Re: Amendment of Prior Approval of Development Plans and Architectural Standards for the Straits Farm subdivision, New Albany County Club Section 27, located on the west side of State Route 605 directly south of Maplewood Cemetery

This letter is to memorialize recent communications between us concerning certain architectural details for the Straits Farm subdivision. The New Albany Company previously reviewed and approved development plans and architectural standards for the subdivision pursuant to a letter dated July 15, 2013 (the "Approval Letter"). This letter is intended to amend the Approval Letter consistent with some revisions that we have recently agreed upon. These amendments are as follows:

Re: Approval of Development Plans and Architectural Standards for the Straits Farm subdivision, New Albany Country Club Section 27, located on the west side of 605 directly south of Maplewood Cemetery.

The New Albany Company has reviewed and conditionally approved the Development Plans and Architectural Standards for the Straits Farm subdivision, New Albany Country Club Section 27, as stated in Section 6 (b) of the Lot Sale and Purchase Agreement between The New Albany Company LLC, a

Plan Type A
 2,980 S.F.
 05.31.13

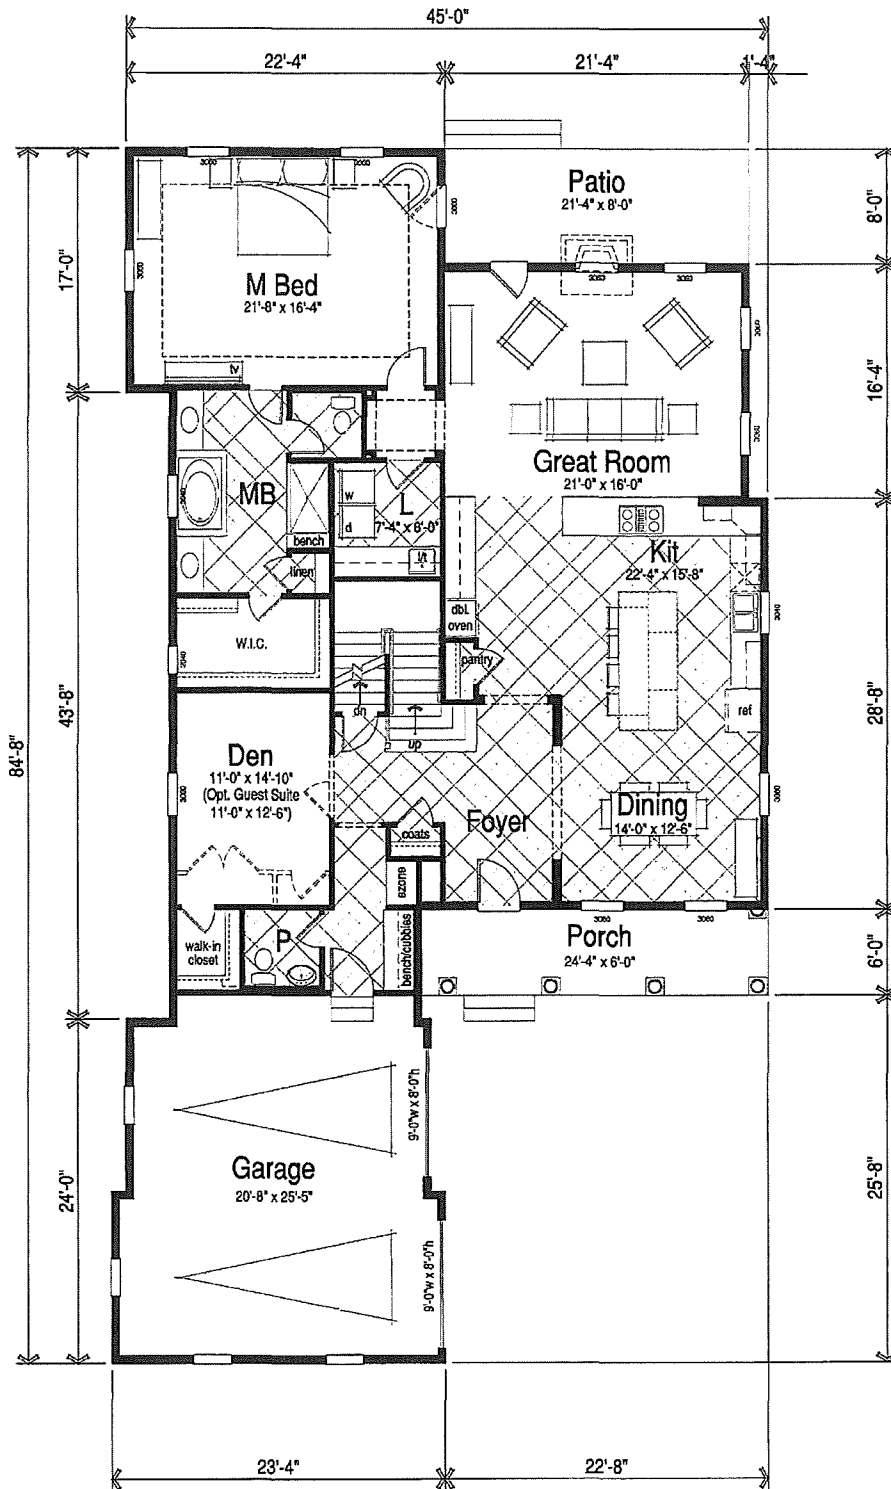
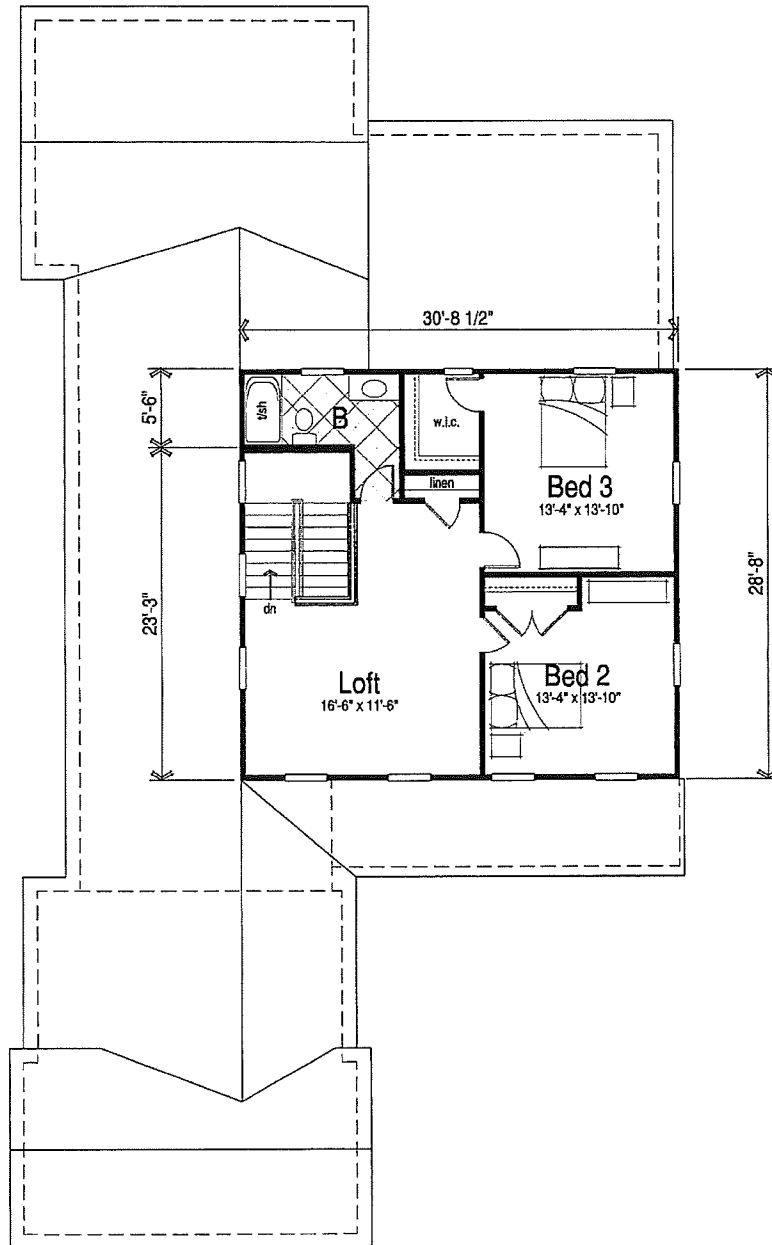
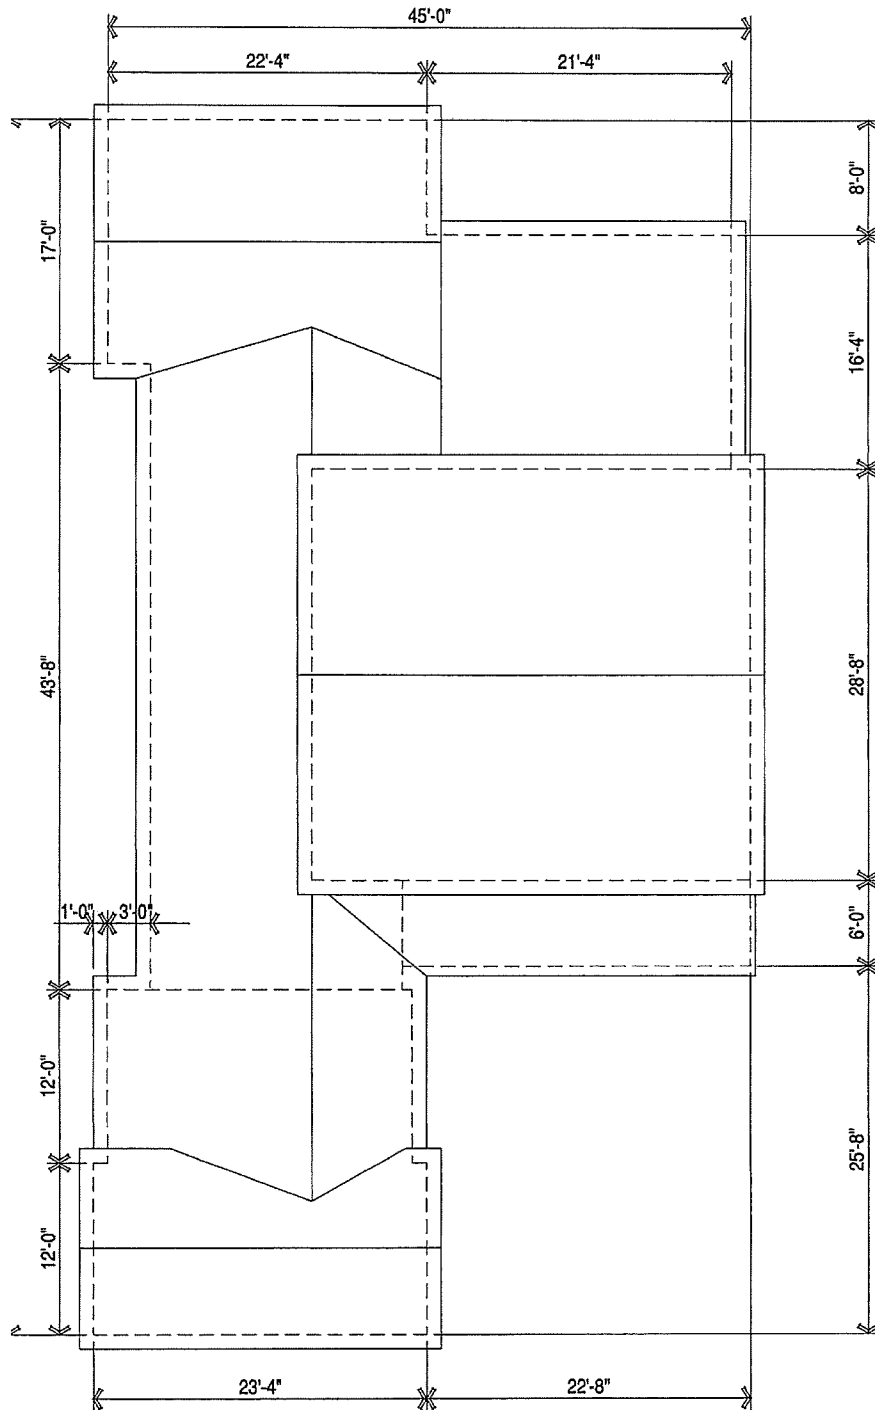
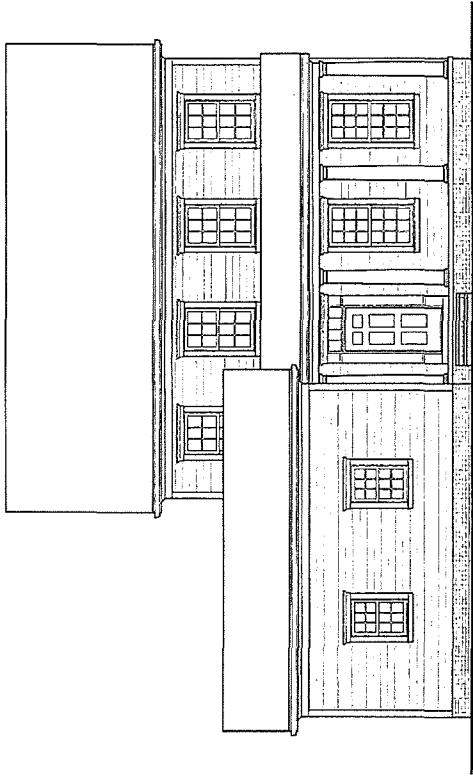
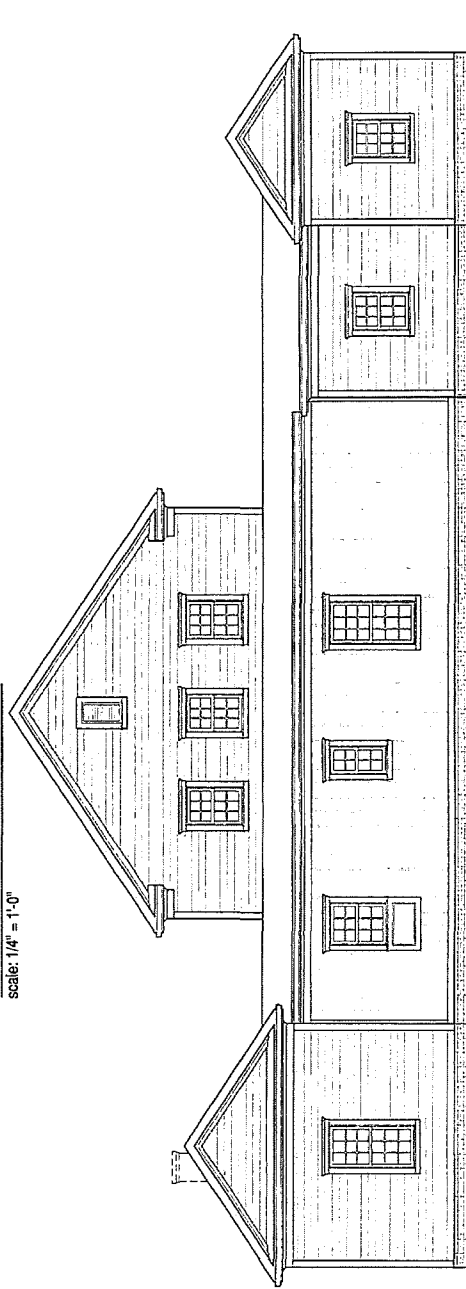
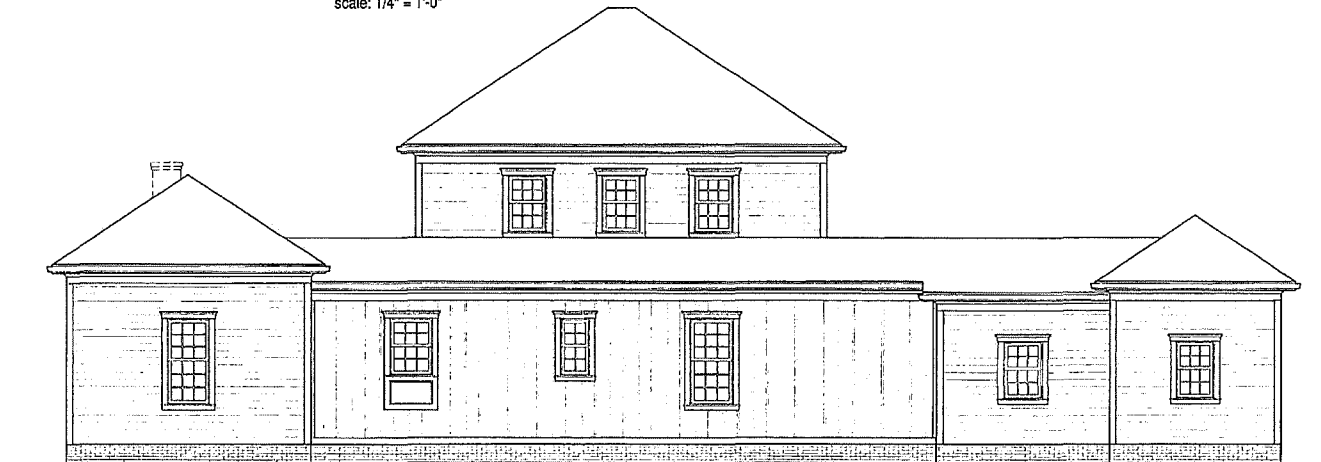
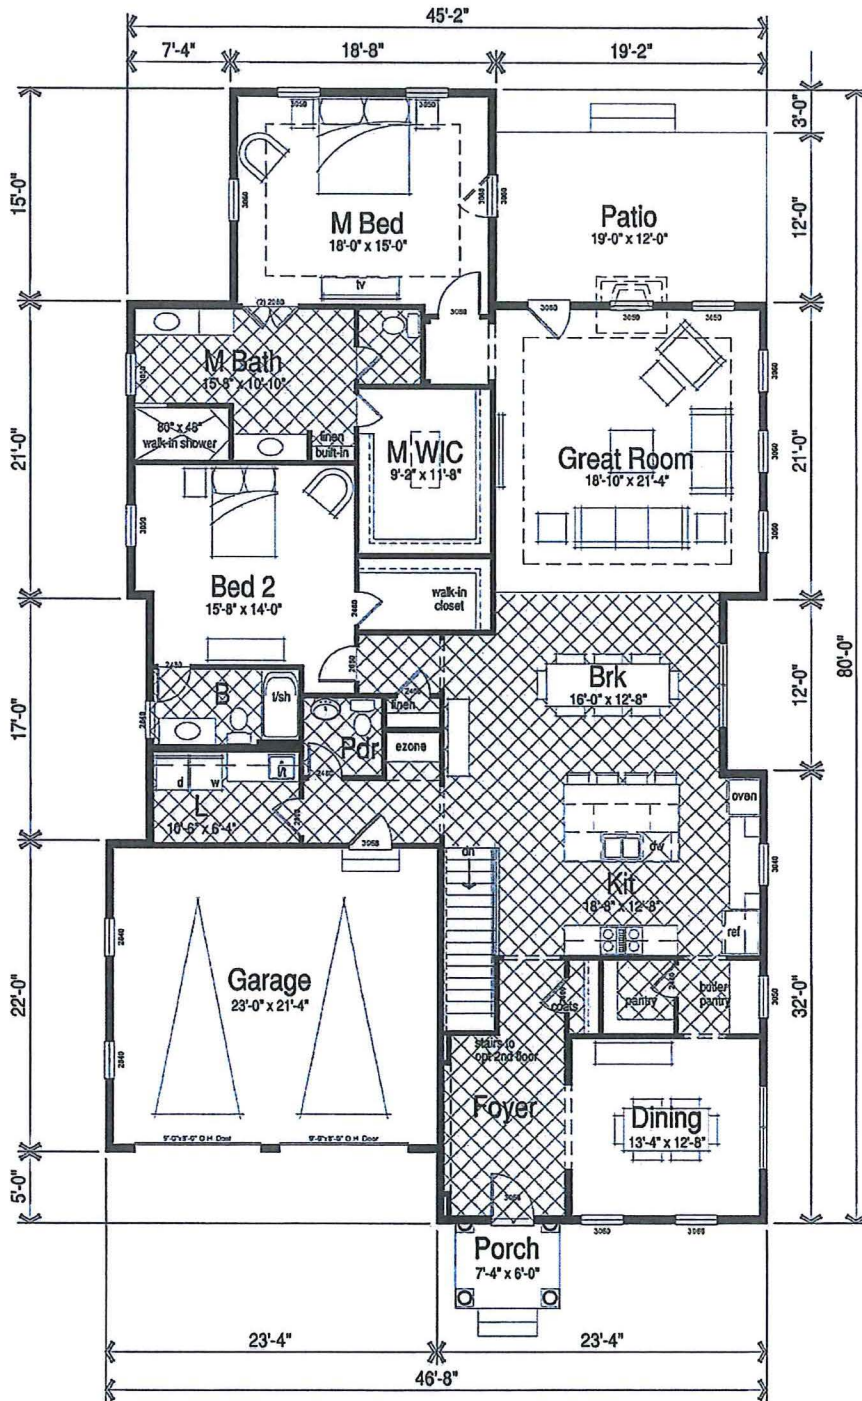
Houses built on lots 1, 2, 3, 4, 5, 6, 7, 8, 9, 14, 24, 28, 32, 41 and 42 shall be brick, as illustrated on attached Exhibit SP-2. The brick construction is limited to all elevations of the main building mass of each house, except that brick shall be required on the garage for House Plan A, and within the pediment on House Plan B if the two story elevation is constructed.

House Plan Types A, B and C, prepared by M/I Homes, dated 5.31.13, and attached hereto are approved as submitted, subject to review and approval of final architectural drawings. Detailed construction and architectural drawings are needed to review and approve items such as cornice details at the roof line, trim details around windows and garage doors, wall sections and column and entry details.

"Homes built on lots 1, 2, 3, 4, 5, 6, 7, 8, 9, 24, 28, 29, 36, 41 and 51 shall be brick, as illustrated on attached Exhibit SP-2. The brick construction is limited to all elevations of the main building mass of each house, except that brick shall be required on the garage for House Plan A, and within the pediment of House Plan B if the two story elevation is constructed."
